**Scientific Analysis/Calculation
Administrative Change Notice**

1. Document Number:	ANL-EBS-MD-000074	2. Revision:	01	3. ACN:	01
4. Title:	Analysis of Dust Deliquescence for FEP Screening				
5. No. of Pages Attached:	5

Figure 6.1-1. Deliquescence of the $\text{NaCl-KNO}_3\text{-NaNO}_3$ System at Elevated Temperature

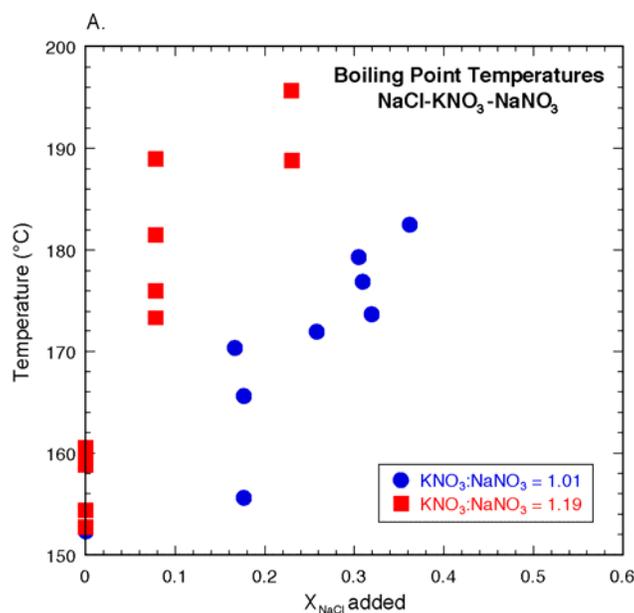
For Section 6.1.2.2, the file *Boiling_temperatures_R1c-1.doc* (“Figure 1”) supplies information regarding the dryout temperature of the NaCl–KNO₃ assemblage being below 160°C (DTN: LL040901831032.008 [DIRS 173659]). Also, Figure 6.1-1 uses data boiling point measurement data from this same file (*Boiling_temperatures_R1c-1.doc*, “Figure 3”).
